NOTICE OF REVISION (NOR)		1. DATE (YYMMDD) 98-06-12	Form Approved OMB No. 0704-0188
THIS REVISION DESCRIBED BELOW HAS BEEN AUTHORIZED FOR THE DOCUMENT LISTED.			
Public reporting burden for this collection is estimated to average 2 hours per response, including the time for reviewing instructions, searching existing data sources, gathering and maintaining the data needed, and completing and reviewing the collection of information. Send comments regarding this burden estimate or any other aspect of this collection of information, including suggestions for reducing this burden, to Department of Defense, Washington Headquarters Services, Directorate for Information Operations and Reports, 1215 Jefferson Davis Highway, Suite 1204, Arlington, VA 22202-4302, and to the Office of Management and Budget, Paperwork Reduction Project (0704-0188), Washington, DC 20503. PLEASE DO NOT RETURN YOUR COMPLETED FORM TO EITHER OF THESE ADDRESSES. RETURN COMPLETED FORM TO THE GOVERNMENT ISSUING CONTRACTING OFFICER FOR THE CONTRACT/ PROCURING ACTIVITY NUMBER LISTED IN ITEM 2 OF THIS FORM.		2. PROCURING ACTIVITY NO.

3. DODAAC	
4. ORIGINATOR	b. ADDRESS (<i>Street, City, State, Zip Code</i>) Defense Suppl

FIGURE A-1

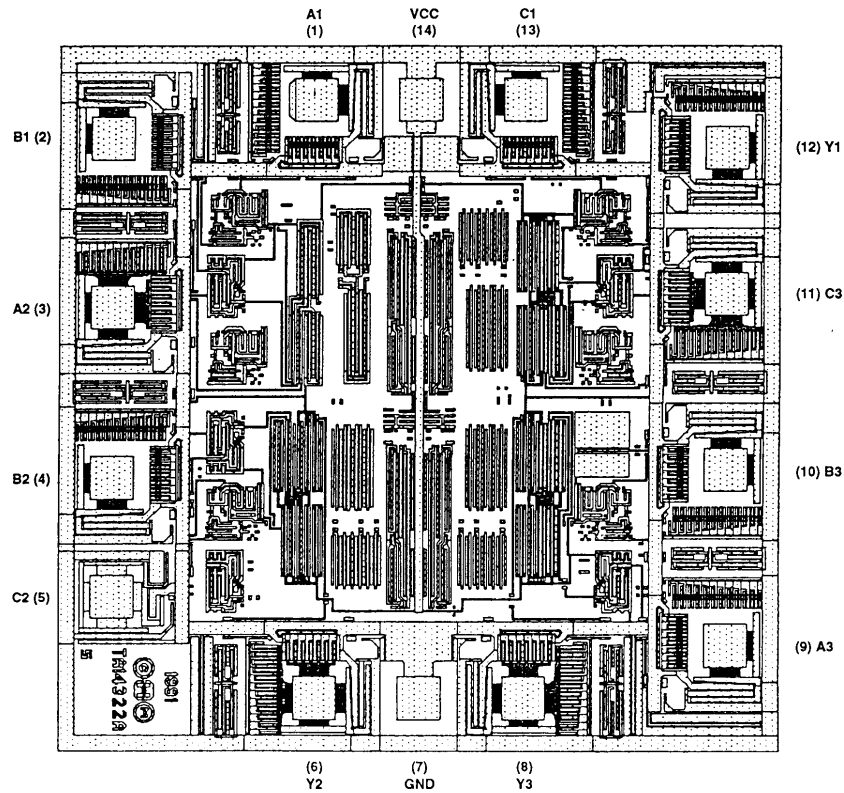
a. CURRENT -	b. NEW A
11. ECP NO. No users listed.			
12. CONFIGURATION ITEM (OR SYSTEM) TO WHICH ECP APPLIES All			
13. DESCRIPTION OF REVISION Sheet 1: Revisions ltr column; add "A". Revisions description column; add "Changes in accordance with NOR 5962-R123-98". Revisions date column; add "98-06-12". Revision level block; add "A". Rev status of sheets; for sheets 1, 4, and 16 through 22, add "A". Sheet 4: Add new paragraph which states; "3.1.1 <u>Microcircuit die</u> . For the requirements for microcircuit die, see appendix A to this document." Revision level block; add "A". Sheets 16 through 22: Add attached appendix A. CONTINUED ON NEXT SHEETS

o DIE PHYSICAL DIMENSIONS

Die Size: 2200 x 2240 microns.
Die Thickness: 21 +/- 2 mils.

• DIE BONDING PAD LOCATIONS AND ELECTRICAL FUNCTIONS

The following metallization diagram supplies the locations and electrical functions of the bonding pads. The internal metallization layout and alphanumeric information contained within this diagram may or may not represent the actual circuit defined by this SMD.

NOTE: Pad numbers reflect terminal numbers when placed in Case Outlines C, X (see Figure 1).
